ITEM #4: For the **ARCHITECTURAL COMMISSION** on **MONDAY, February 8th @ 7:00 P.M.**

REQUEST: Consideration of preliminary plans & plats including landscaping and signage for the proposed “Karen’s Corner” PUD/ Subdivision in conjunction with the petition for a SUP/PUD development as submitted by Fidelity Wes for property located at Checker Road and Old Hicks commonly known at the Iverson Property.

RE: Iverson Property – aka KAREN'S CORNER

PRELIMINARY PLAT OF SUBDIVISION
OF
KAREN'S CORNER OF LONG GROVE

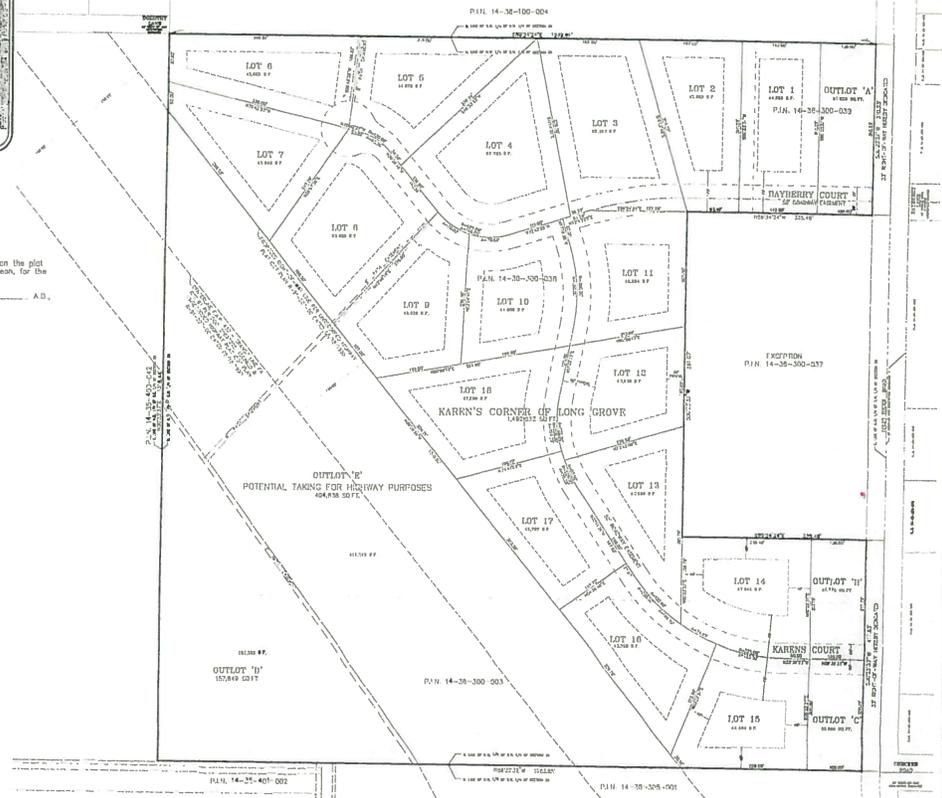
The PUD Plat in combination with the proposed site plan is in conformance with the Village regulations with the exception of a soils map depicting soil conditions on the entire site. Conservancy soils & wetlands have been identified on the plat however.

A 100' scenic corridor easement is depicted along Old Hicks Road as required by the Village Subdivision Regulations which will be reviewed by the CSCC at their February 3rd meeting.

50' road easements are proposed with a 24' pavement width.

The Route 53 right-of-way also looms large with the plan and plat as proposed for this property as the anticipated path of the roadway impacts this property. Although there is presently substantial interest in making this roadway a reality, solid plans for the extension do not exist. In short, the roadway extension may or may not occur. The plans are sensitive to this possibility and an additional 10 acres of property (404,836 sq. ft.) proposed as “open space” and identified as “Outlot E” on the preliminary plat of subdivision is reserved and identified as a “potential taking for highway purposes”. This land is calculated into the overall density for the site as this land does not presently constitute a right-of-way.

Any comments the AC may have regarding the design of the development may be incorporated in the recommendation of the AC. At a minimum acceptance of the preliminary plan and plat as submitted is suggested.
